## ORIGINATION FORM

Proposed Revisions to a Standard Plans Index  
(Please provide all information — Incomplete forms will be returned)

Index Number: 102-606  
Sheet Number (s): 1 of 1  
Index Title: Two-Lane Roadway, Lane Closure Using  
Temporary Traffic Signals

LAST REVISION <del>11/01/20</del>	DESCRIPTION:	 FY 2021-22 STANDARD PLANS	TWO-LANE ROADWAY, LANE CLOSURE USING TEMPORARY TRAFFIC SIGNALS	INDEX 102-606	SHEET 1 of 1
--------------------------------------	--------------	----------------------------------	---	------------------	-----------------

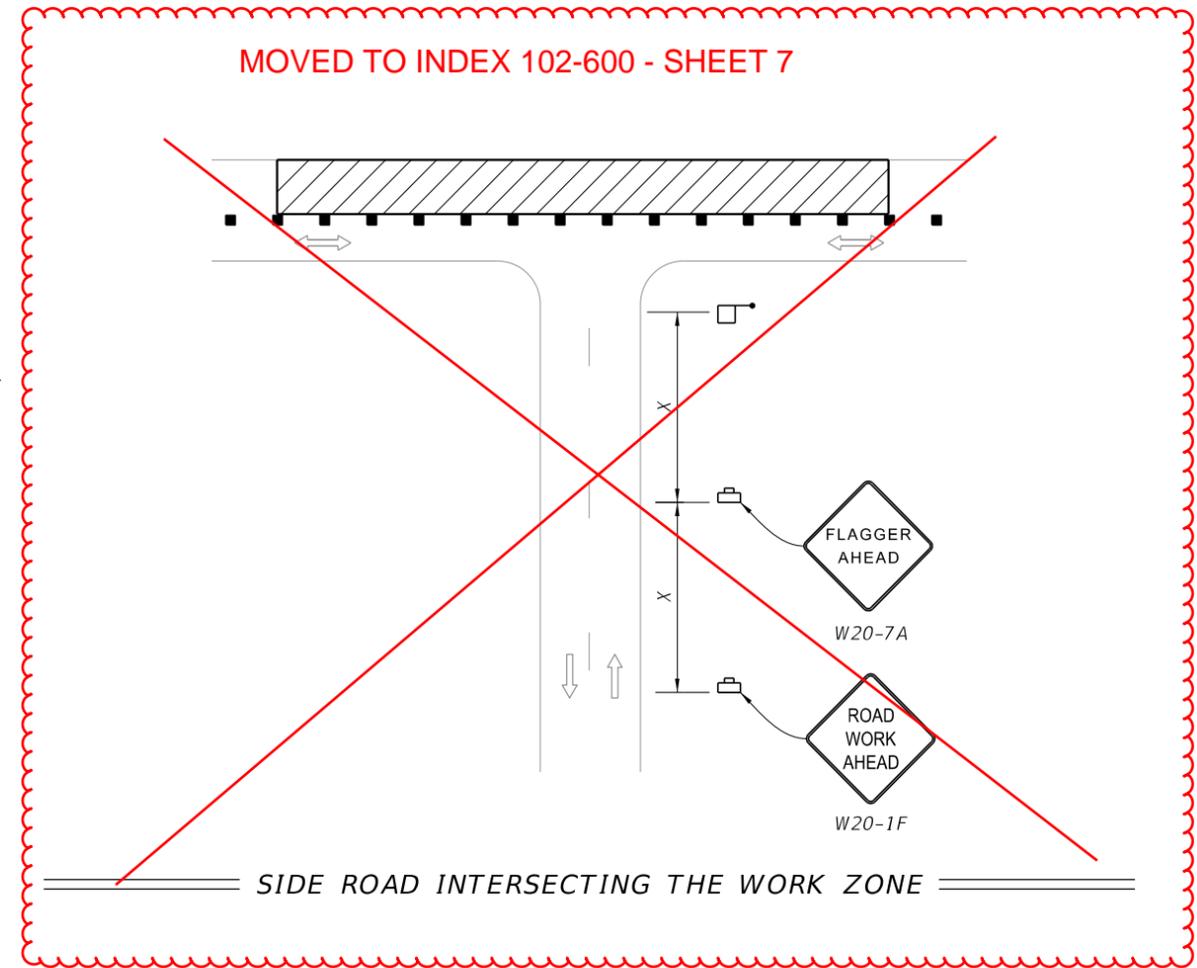
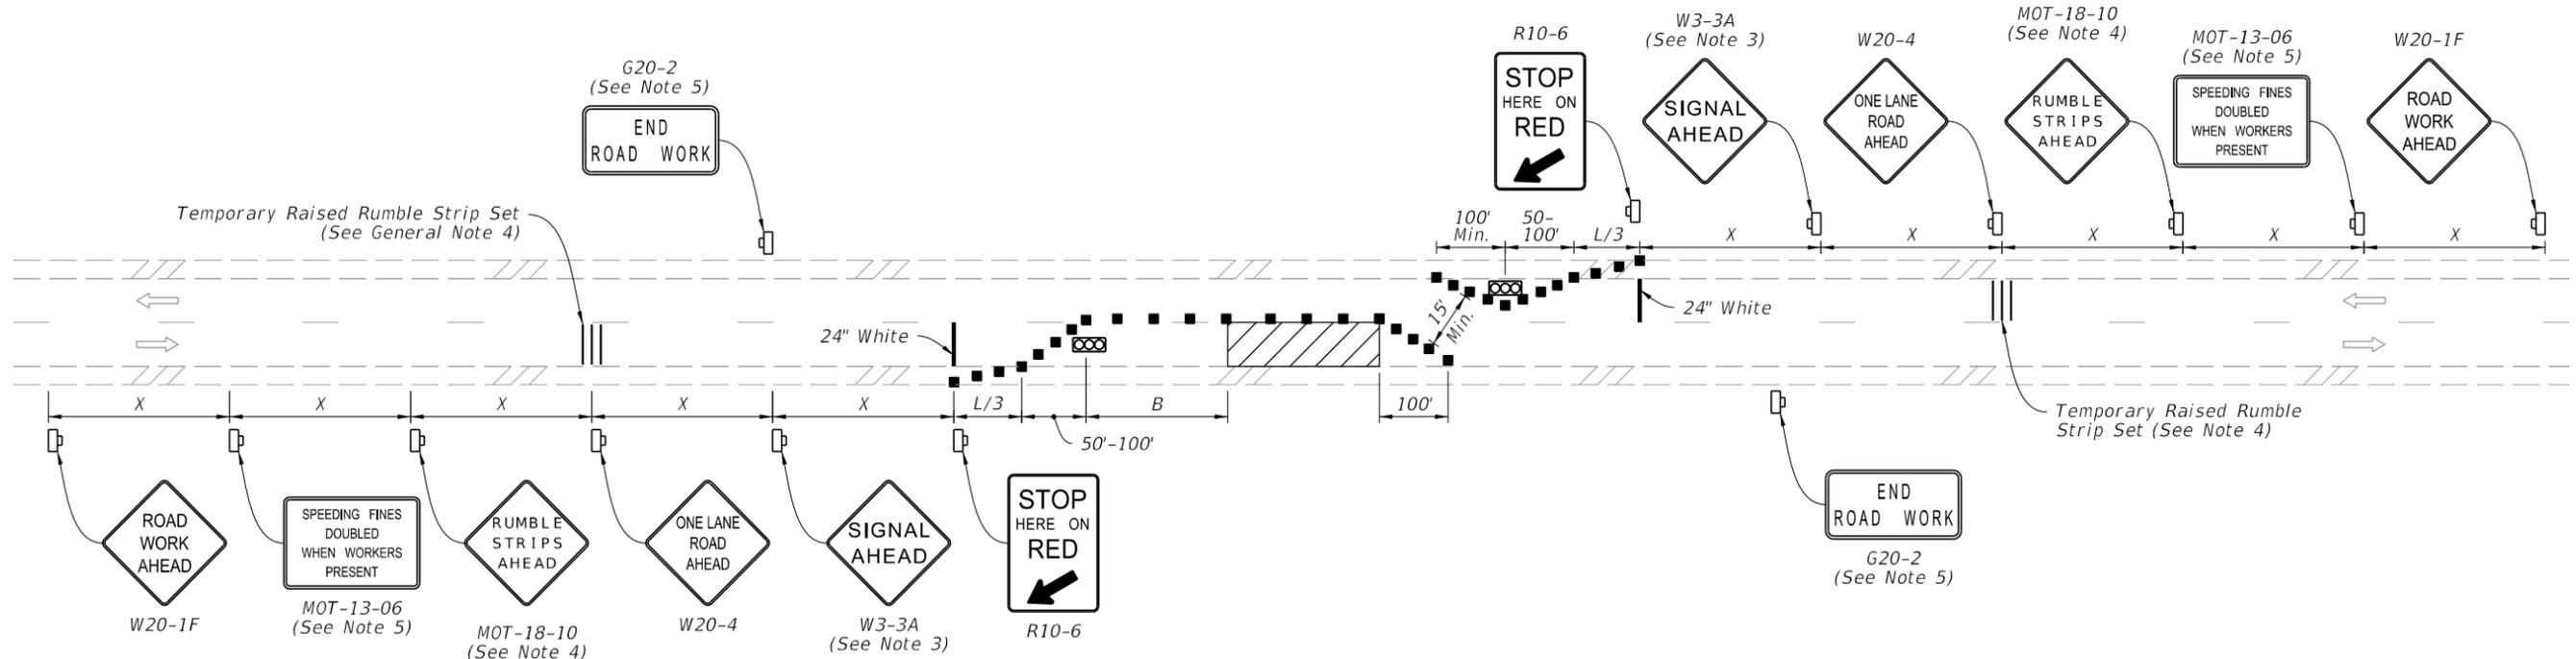
Sheet 1: Changed Note 5 - "work zone" to "work operation"; Changed Note 8 - "ridable shoulder" to "4' or greater paved Shoulder"; Moved the SIDE ROAD INTERSECTIN THE WORK ZONE detail to Index 102-600 - Sheet 7.

The duration provisions of the index are intended to apply to the length time needed to perform the specific temporary traffic control work "operation" shown, which is independent of the duration of an overall construction project. The term "Work Zone" is being replaced with "Work Operation" to clarify the intent.

**CHANGED TO: operation**

**CHANGED TO: 4' or greater paved**
